Subdivision and Land Development Cover
Page for SLD # 01-22

Project Name: 931 Spring Mill Avenue, LLC

Date: May 9, 2022

As requested, we have reviewed plans for the above referenced 14-Sheet Land Development Plan submission, prepared by Cornerstone Consulting Engineers & Architectural, Inc., dated December 30, 2021, with revisions dated March 4, 2022 and May 6, 2022. For this letter, we have also reviewed a six-sheet architectural plan set by RHC Design LLC, dated May 6, 2022. This proposal involves parcels at 927 through 931 Spring Mill Avenue. A 20-unit apartment building is proposed with sub-surface parking; a single-family attached dwelling unit on 927 Spring Mill Avenue (half of a twin dwelling) is also being retained and is part of this proposal. The following are the current Zoning Ordinance issues identified with respect to this proposal. We have used our preliminary plan zoning compliance review letter dated February 3, 2022 and Cornerstone Consulting Engineer's response letter as the basis for this review; for ease of reference, comment numbers are the same as the corresponding comment numbers in our February 3rd letter. Our responses are in bold following the original

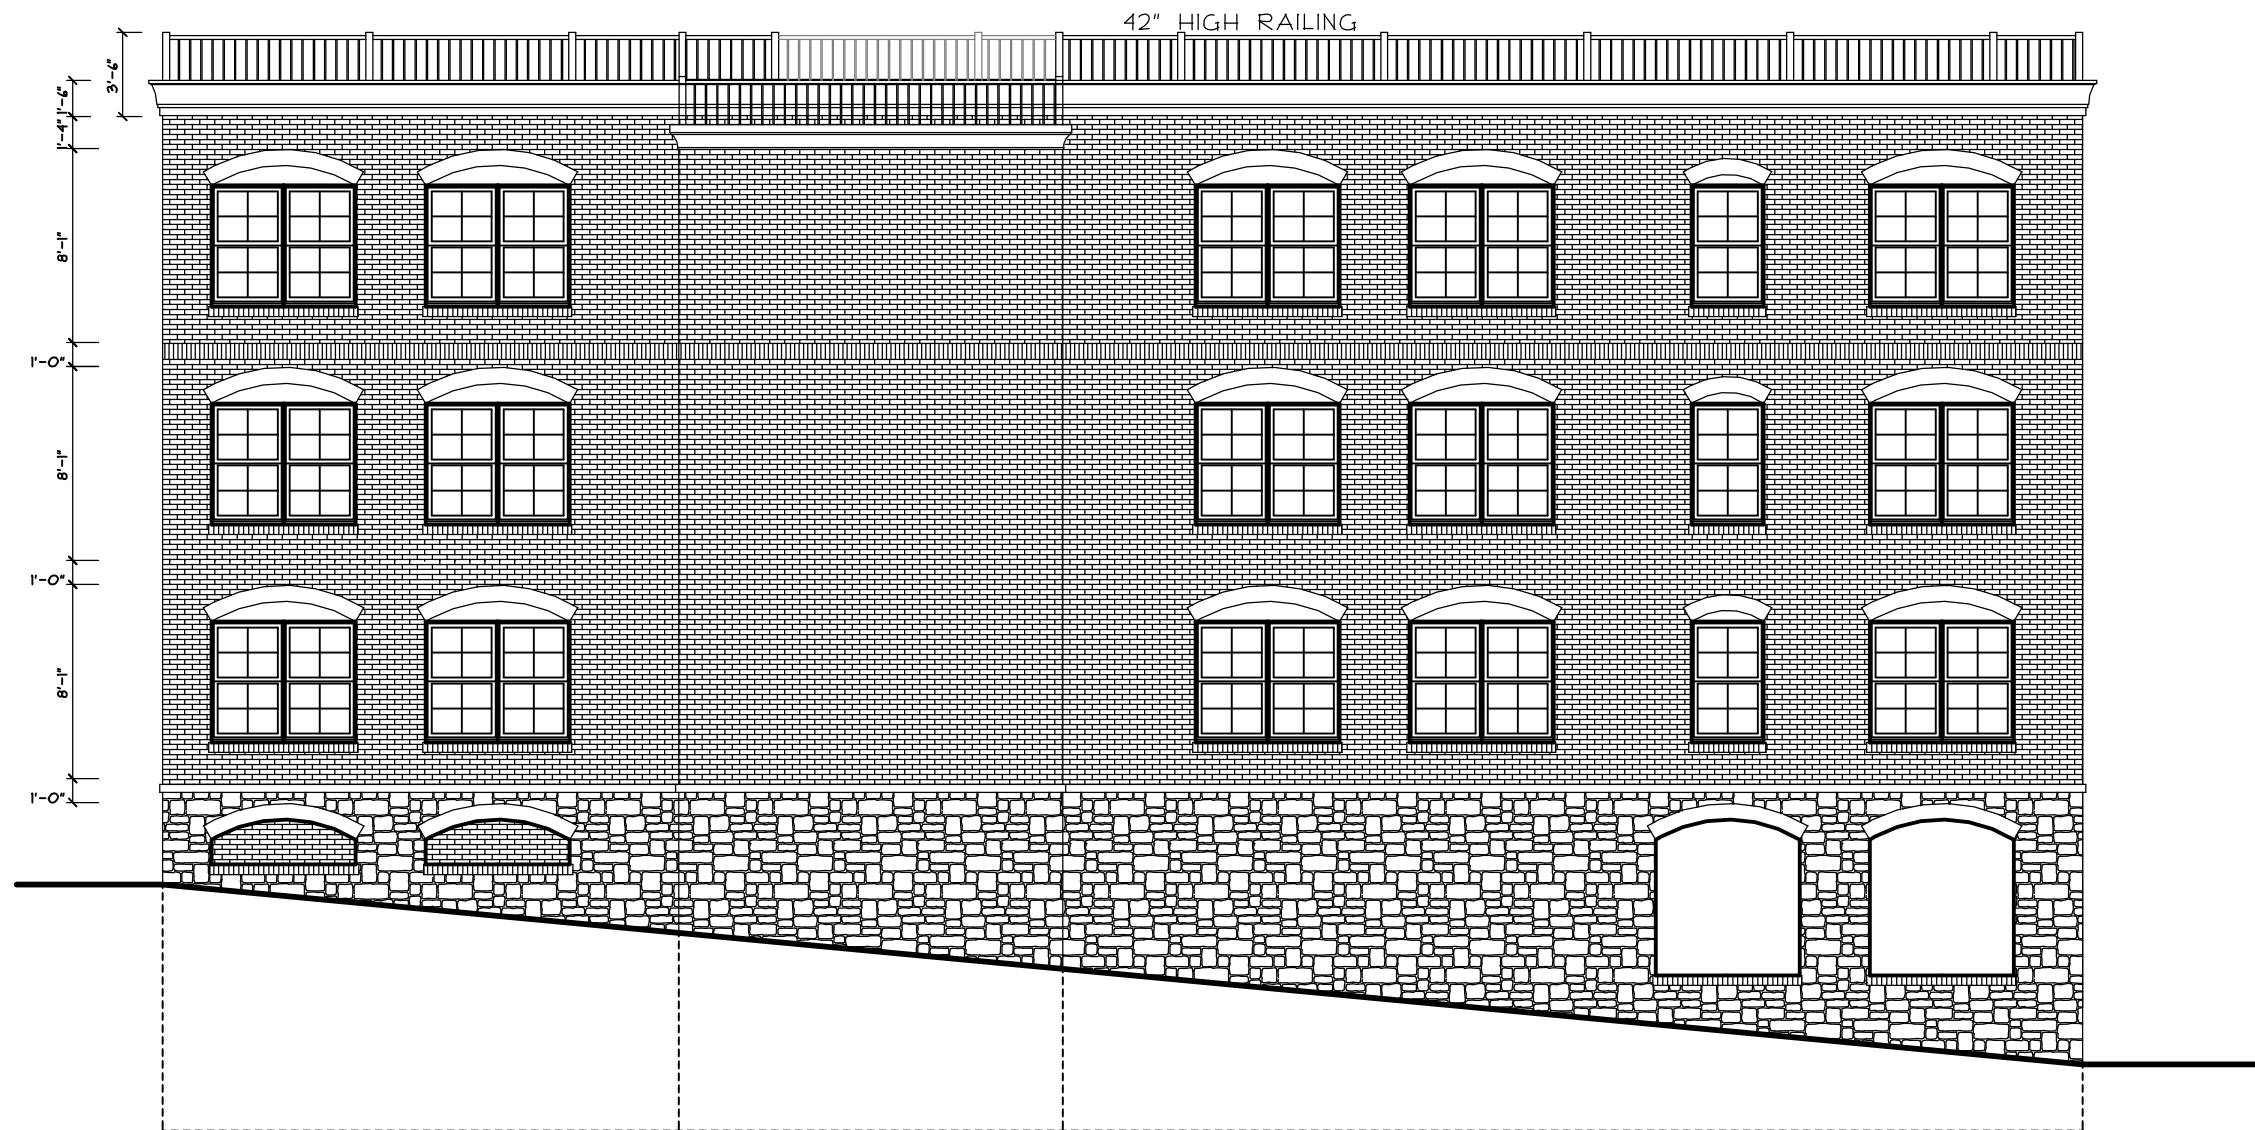
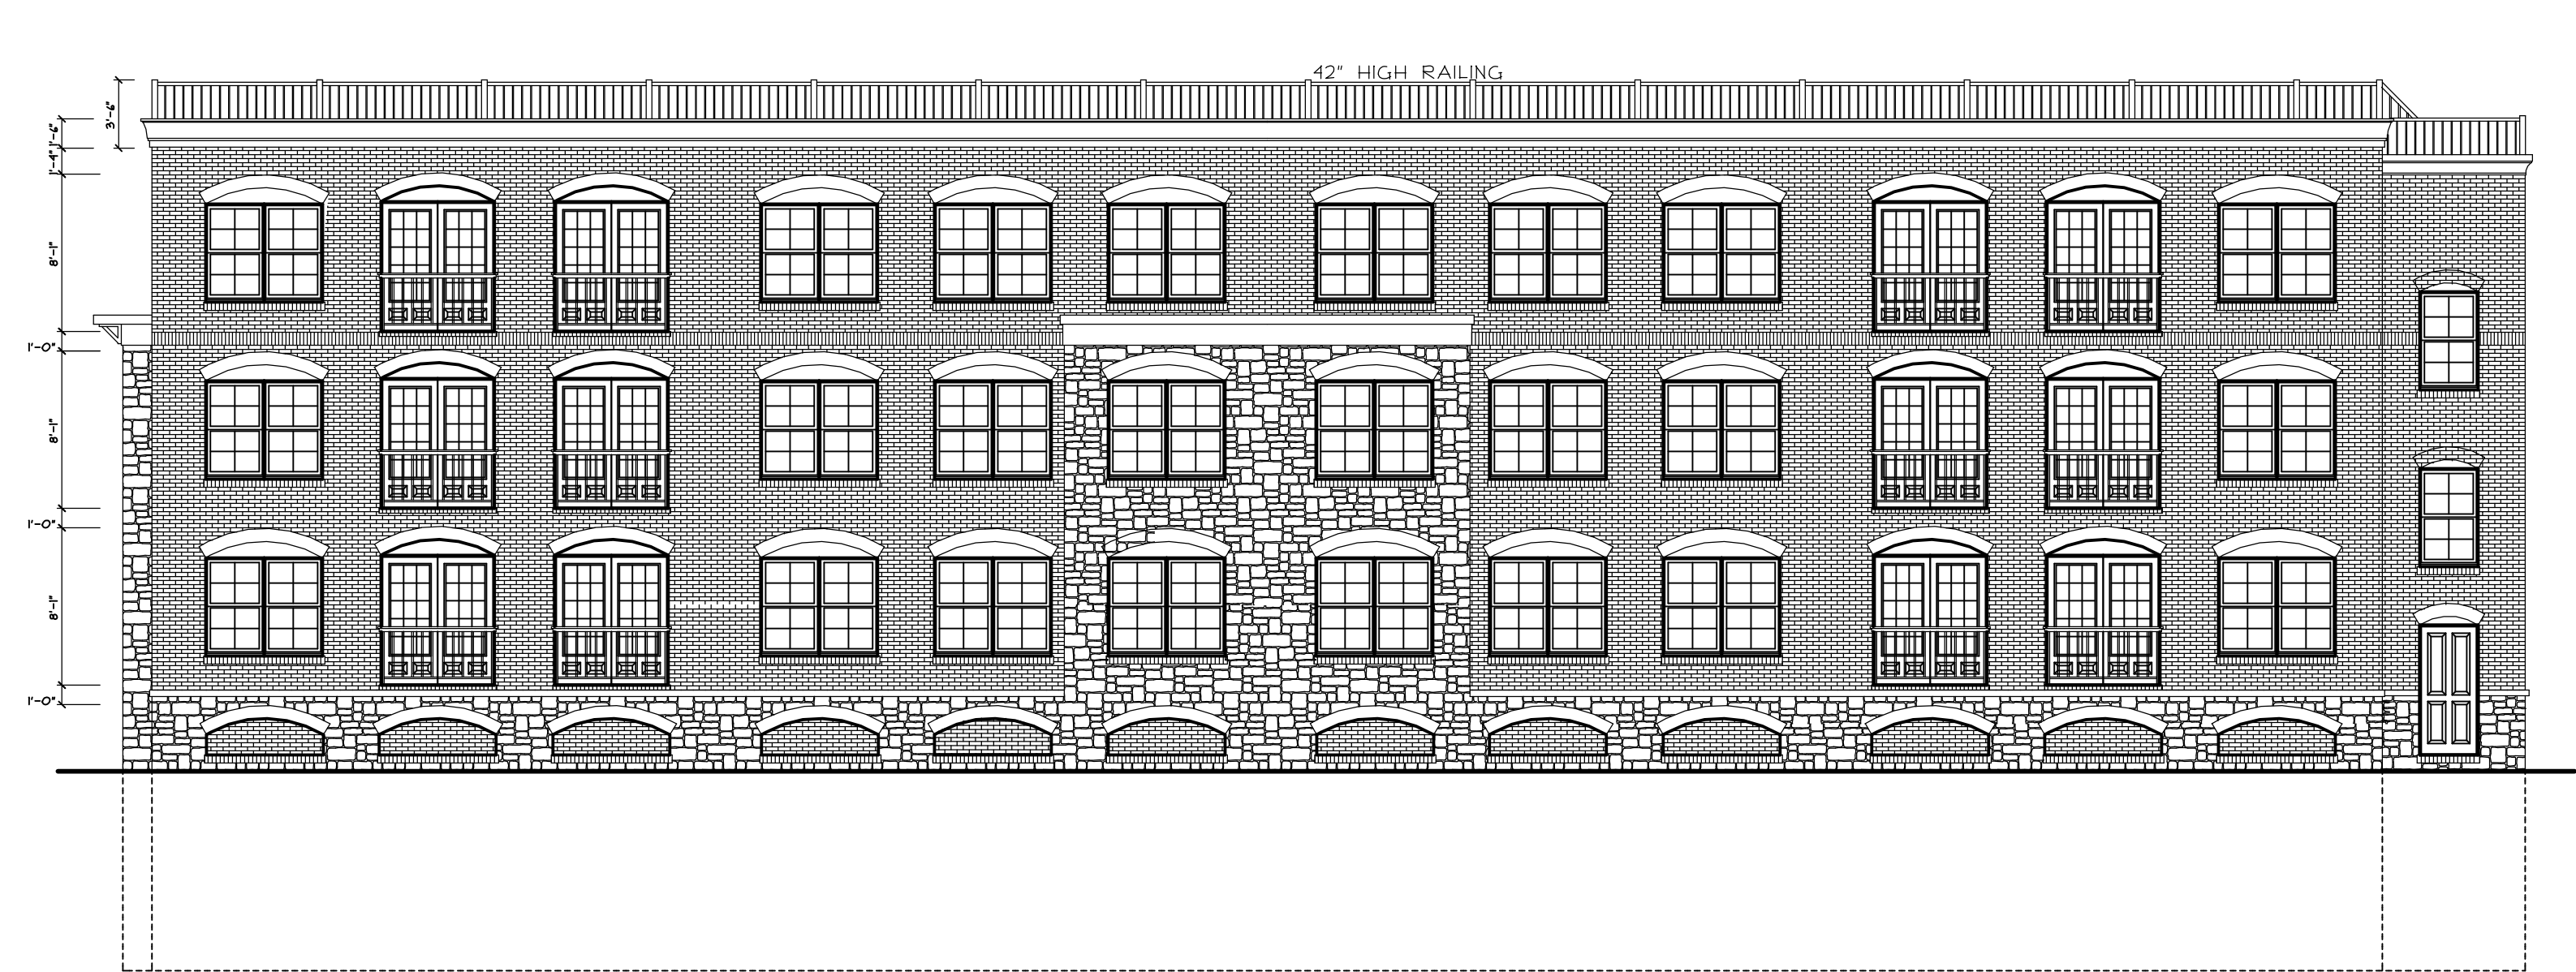
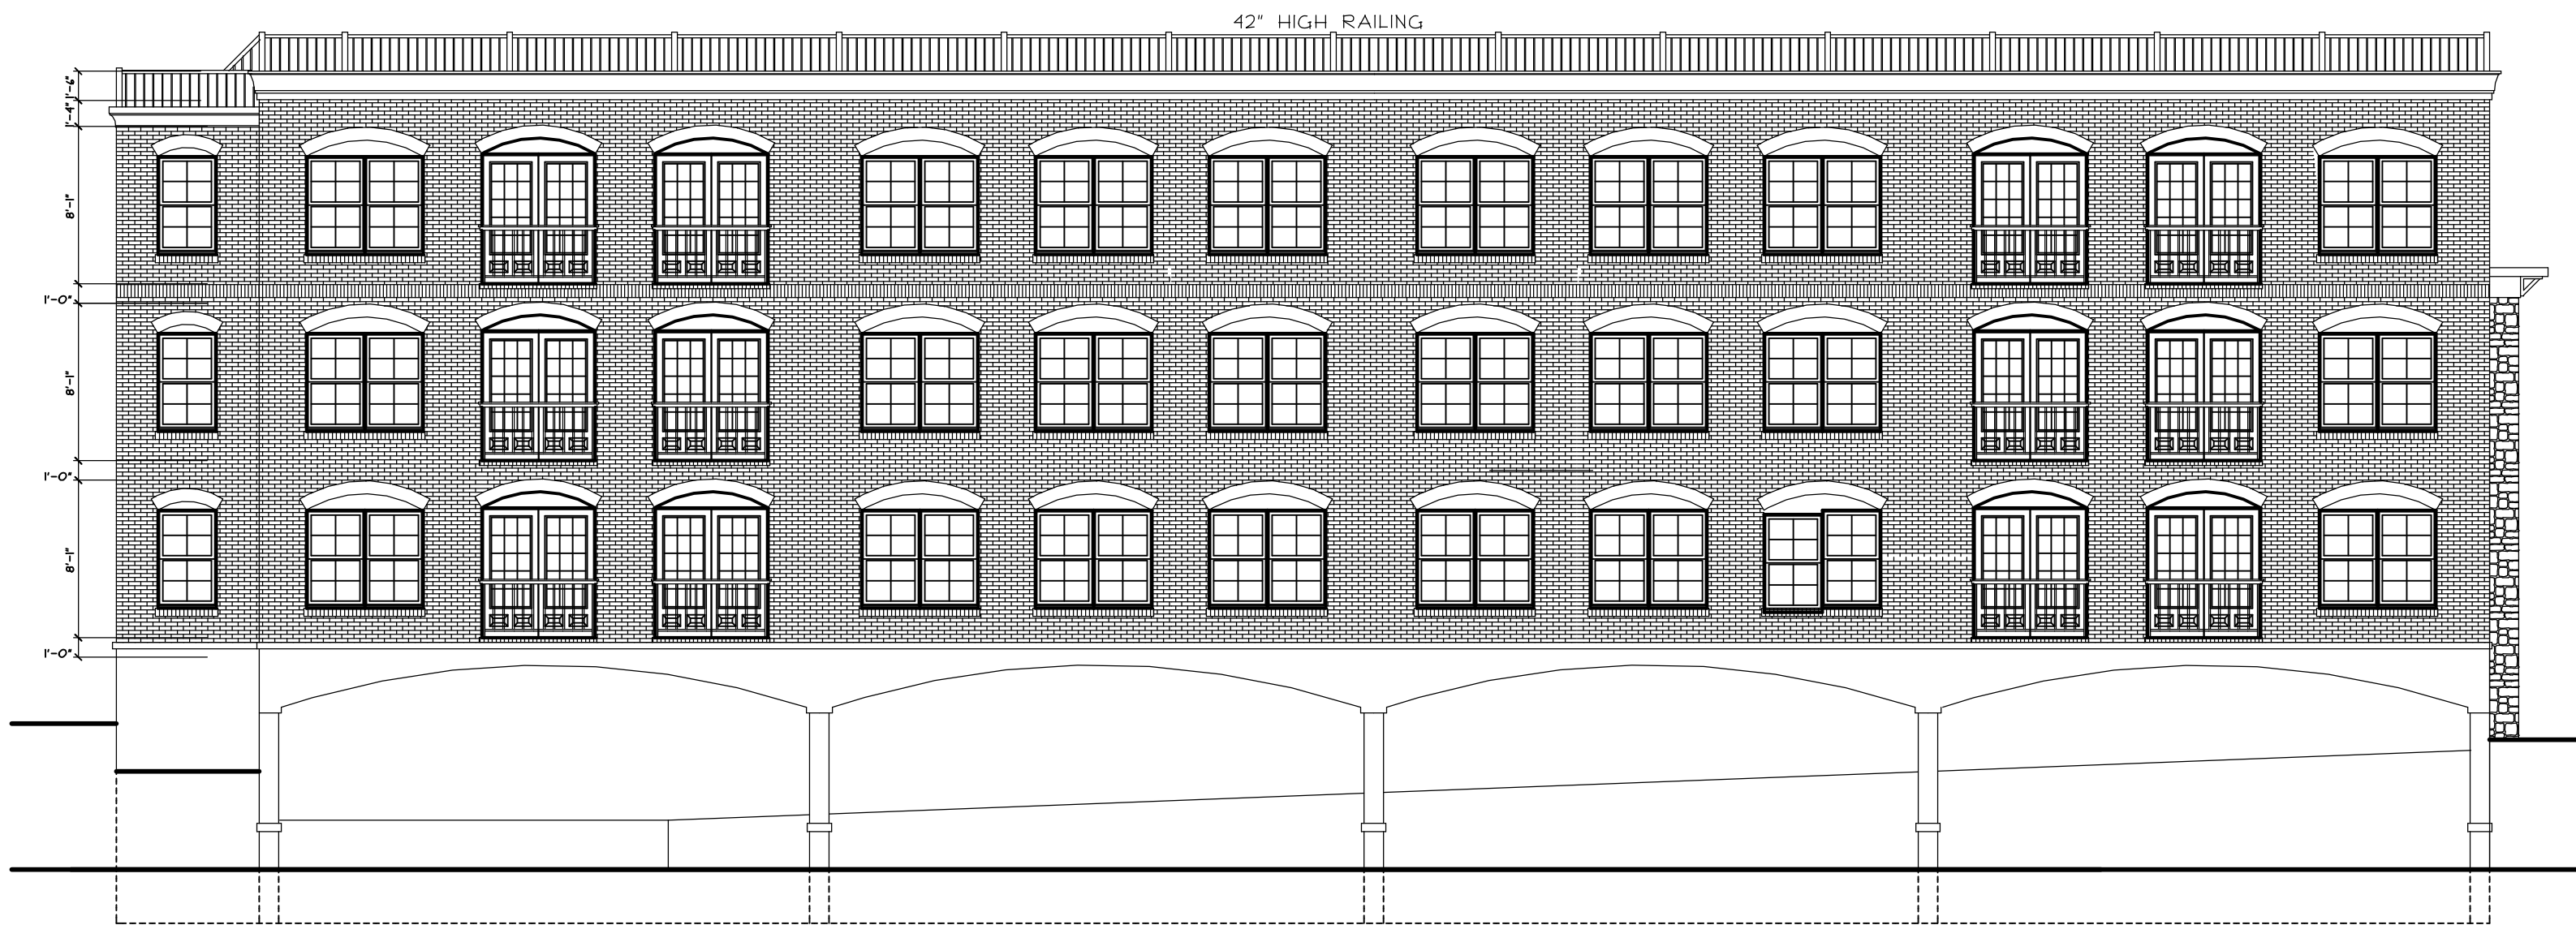
17. §116-282.A. Parking structures shall have another permitted first floor use on any portion of the structure visible from any streets or suitable architectural treatment shall be provided.
The elevations provided on plans A-5 and A-6 show what appears to be brick on many of the garage window openings. Please confirm if this understanding is correct; provide a detail for these window openings if the material shown is something other than brick; also please confirm that the other 'windows' shown without a brick pattern, are unobstructed openings.
